গণপ্রজাতন্ত্রী বাংলাদেশ সরকার
শ্রম ও কর্মসংস্থান মন্ত্রণালয়
কলকারখানা ও প্রতিষ্ঠান পরিদর্শন অধিদপ্তর

ক্যাপ পর্যবেক্ষণের তথ্য

| কারখানার নাম | কোজিমা লিরিক গার্মেন্টস লি: |
| মূল্যায়নের ধরণ: বৈদ্যুতিক মূল্যায়ন | পর্যবেক্ষণের তারিখ: ৩০-০১-২০২৩ |

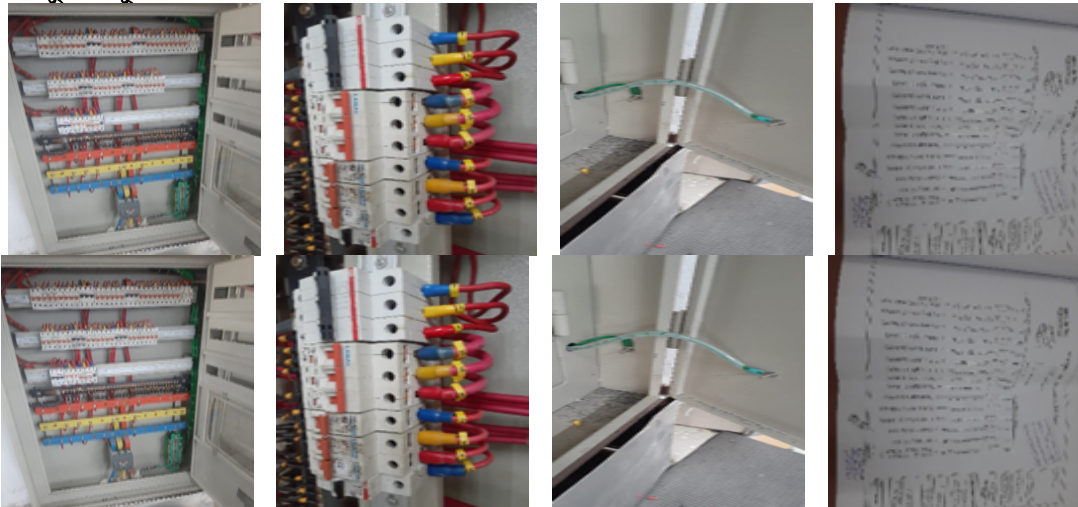
| পরিদর্শন পর্যবেক্ষণ | <input type="checkbox"/> Separating wall not extended up to the ceiling <input type="checkbox"/> Improper door <input type="checkbox"/> Panel body & door not earthed <input type="checkbox"/> No clear identification mark on distribution panel <input type="checkbox"/> No instruction for first aid to electrical shock |

| কার্যক্রম | <input type="checkbox"/> Produce design drawings to demonstrate the incorporation of fire rated enclosure from floor to ceiling and an approved fire rated self-closing swing door for the Substation room. <input type="checkbox"/> Ensure earthing of panel body & door. <input type="checkbox"/> Provide clear identification mark on distribution panel. |
| মন্তব্য | <p>01.10.2020: They are changing DB boards according to approved drawing. Panel and doors are not earthed every panel but they are on to it, there are identification mark on some boards , no first aid instruction so far. 7.01.2021 CVV 3: Separating wall extended up to the ceiling but yet to install fire door, Panel and doors are not earthed every panel ,fir aid instruction board not hanged in every panels, some identification is permanent some are not. 08.06.2021: Separating wall extended up to the ceiling but install fire door, Panel and doors are not earthed every panel ,fir aid instruction board not hanged in every panels, some identification is permanent some are not. 25.08.2021: Separating wall extended up to the ceiling but install fire door, Panel and doors are not earthed every panel ,fir aid instruction board not hanged in every panels, some identification is permanent some are not. 04-08-2022 : Separating wall extended up to the ceiling but install fire door, Panel and doors are not earthed every panel ,fir aid instruction board not hanged in every panels, some identification is permanent some are not. 30-01-2023: Separation wall extend till ceiling. Fire door installed where required. Door Earth connection found ok. Clear identification marking found in DB's. Danger sign placed in every DB's.</p> |
